Transmitted by the expert from Germany

Informal Document No. GRRF-63-08
(63rd GRRF, 4 - 8 February 2008,
agenda item 3(h))

PROPOSAL FOR DRAFT AMENDMENTS TO REGULATION No. 13

(Braking)

FIGURE 1A

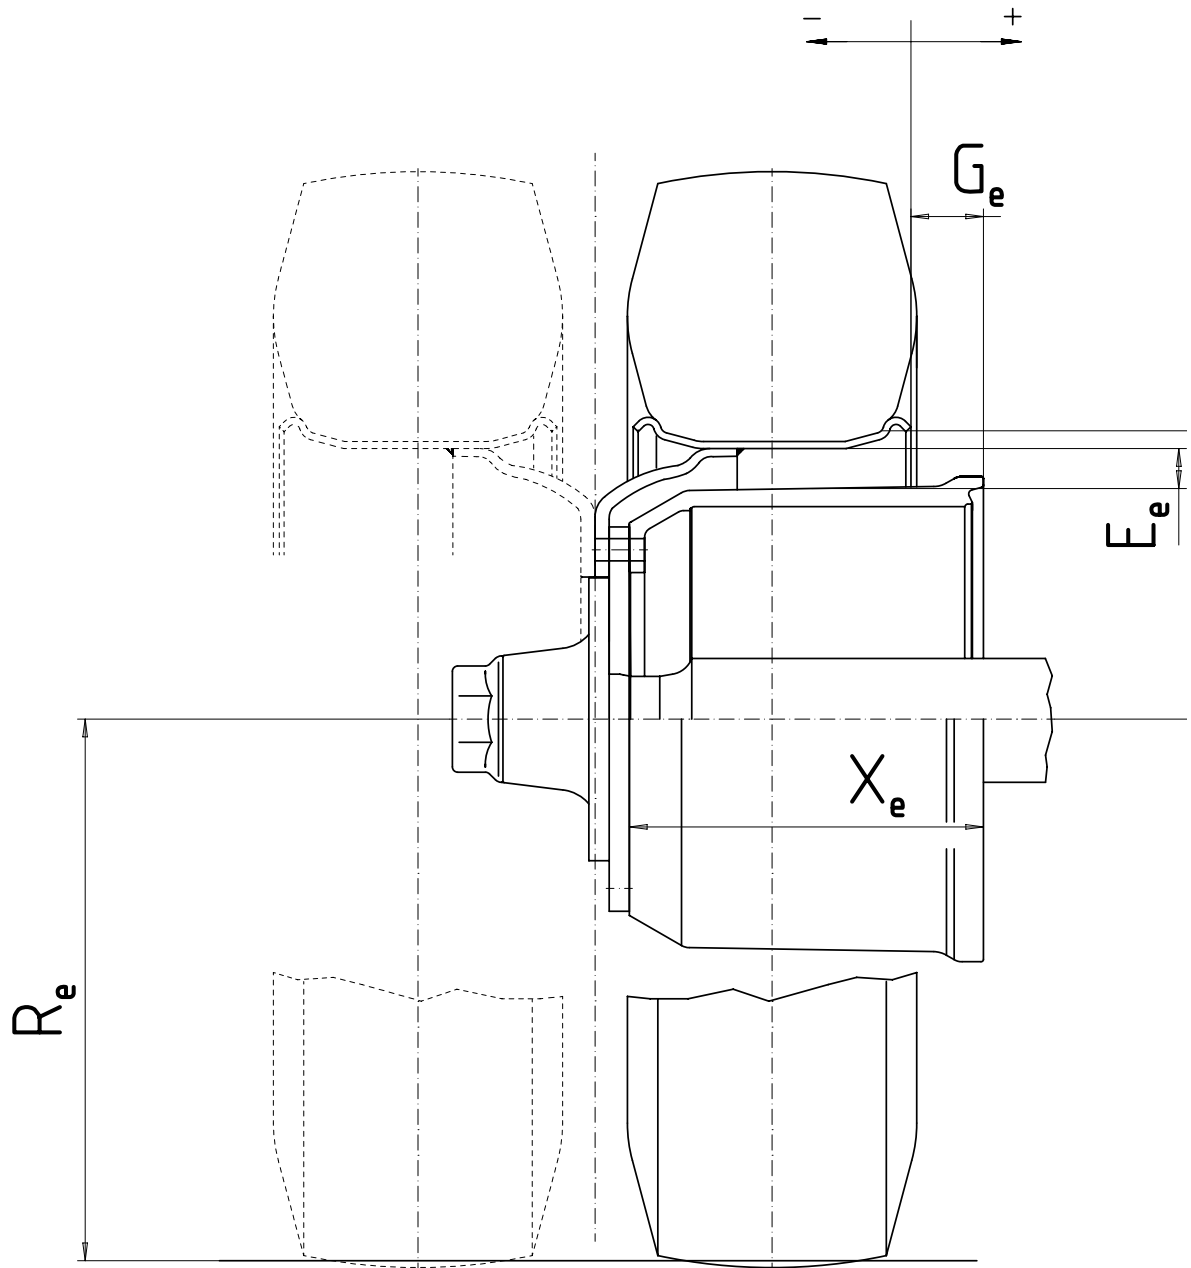
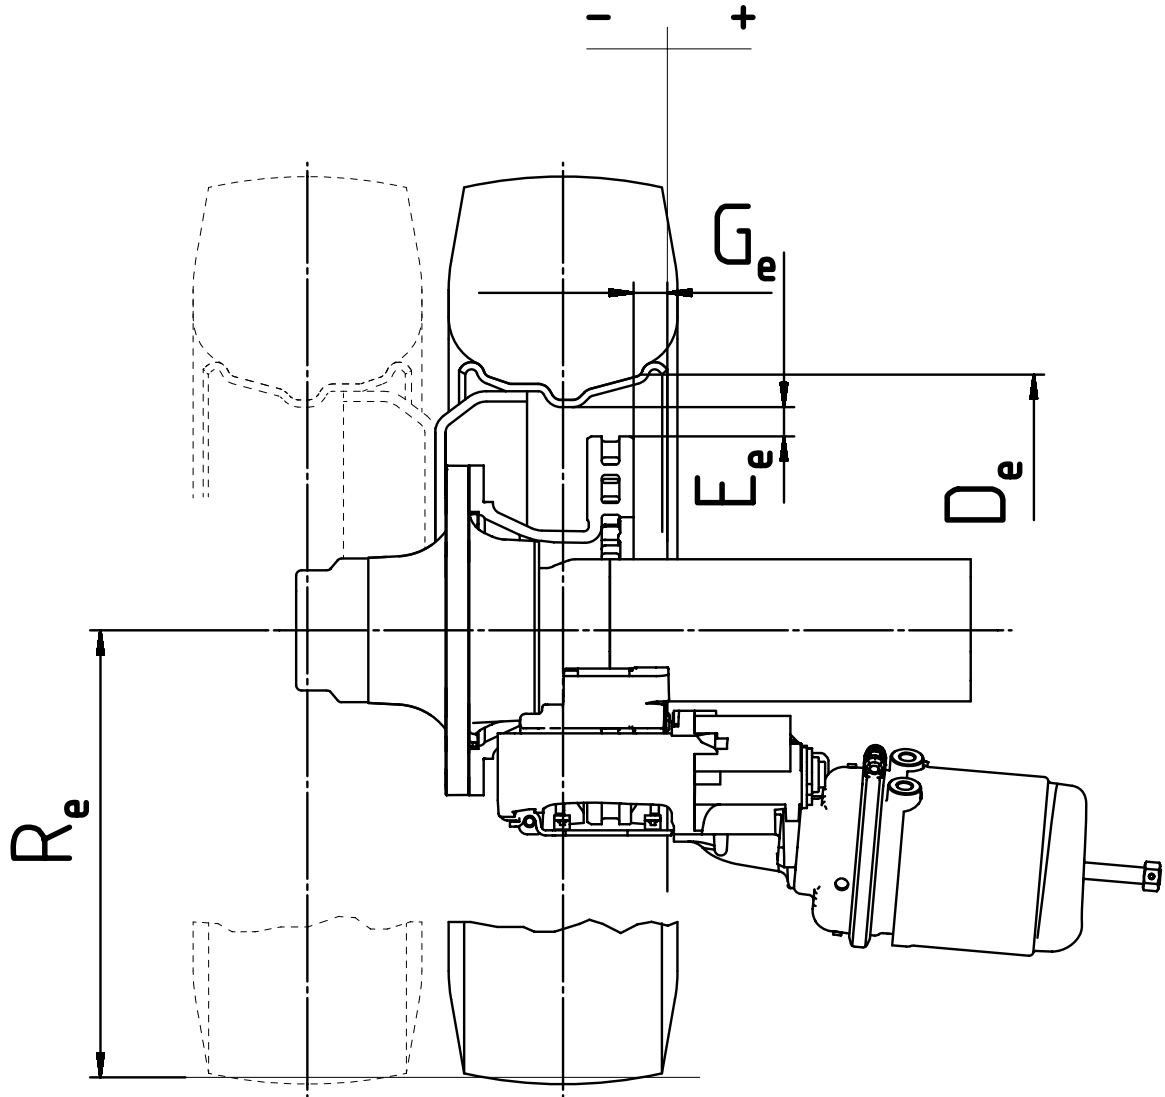
Annex 11 Appendix 5, figures 1A and 1B: dimension B_e deleted as not applicable. Symbol F_e replaced by G_e . – Dimension for D_e corrected. Plus and minus signs added for the dimension G_e .

FIGURE 2A

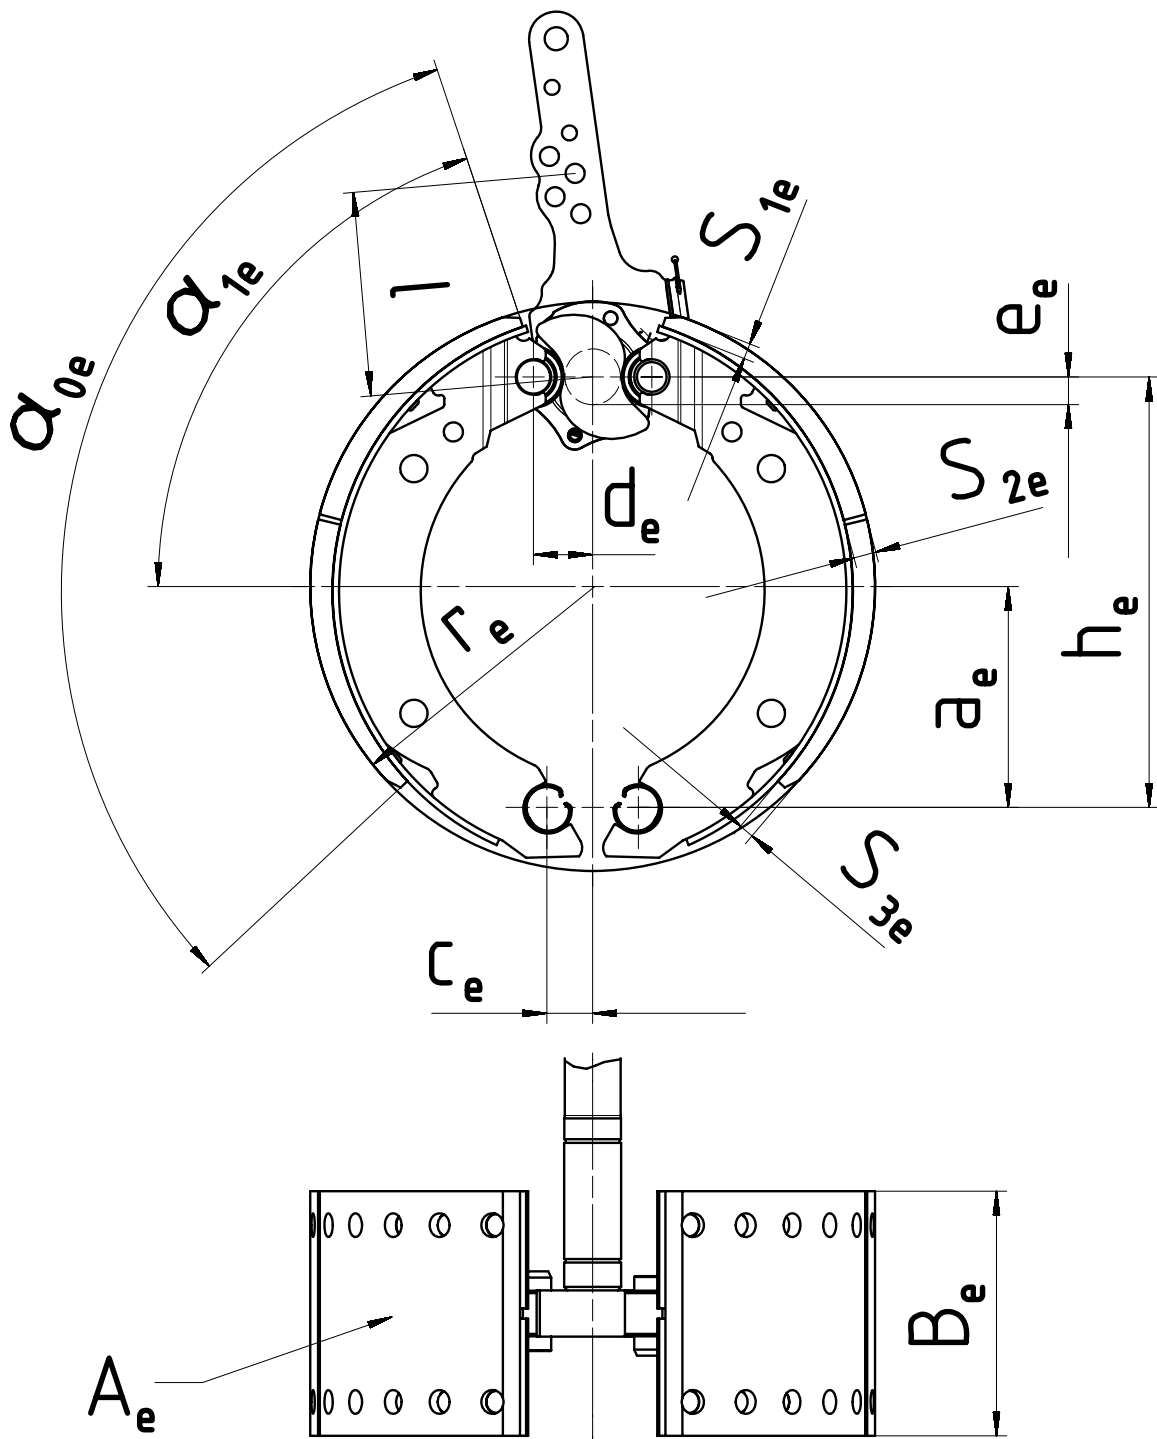
Annex 11 Appendix 5, figures 2A and 2B: Symbol F_e replaced by A_e .
